DEPARTMENT OF HEALTH AND SOCIAL SERVICES
MCLAUGHLIN YOUTH CENTER
ANCHORAGE, ALASKA

ADDENDUM NO. 2

SUBJECT: REQUEST FOR PROPOSALS
McLaughlin Youth Center Boiler Renovation & Replacement

Sketch-01

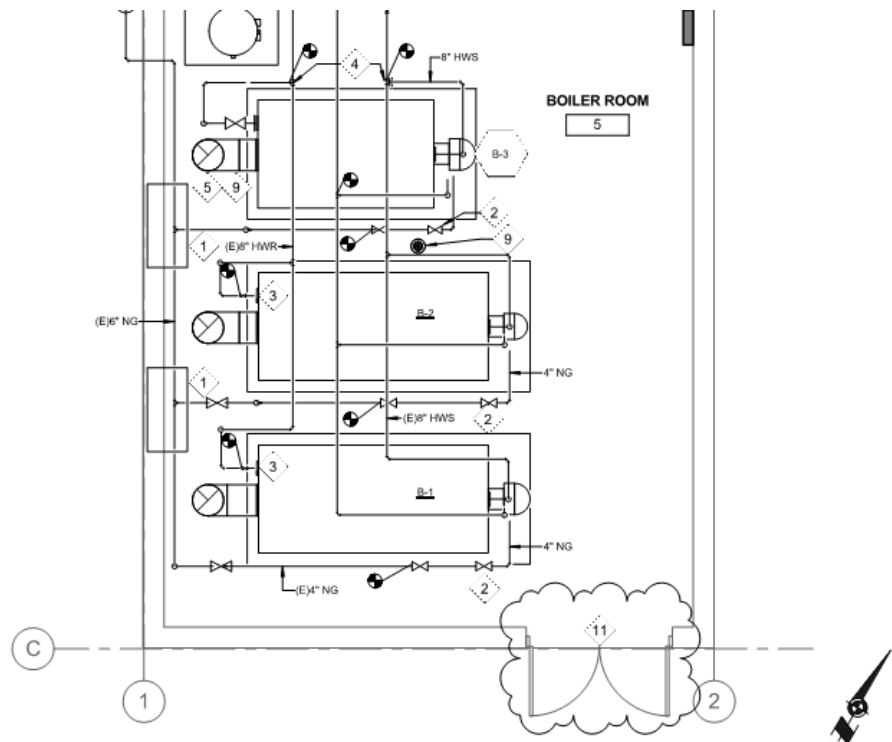
2. Sheet M101, **ADD** Sheet Key Note 9, "DEMOLISH BOILER ROOM DOOR FRAME AND FLASHINGS, RETAIN EXISTING DOORS AND HARDWARE FOR REINSTALLATION. NOTE COLOR PRIOR TO DEMOLITION. PROVIDE TEMPORARY SECURE ACCESS DURING CONSTRUCTION."
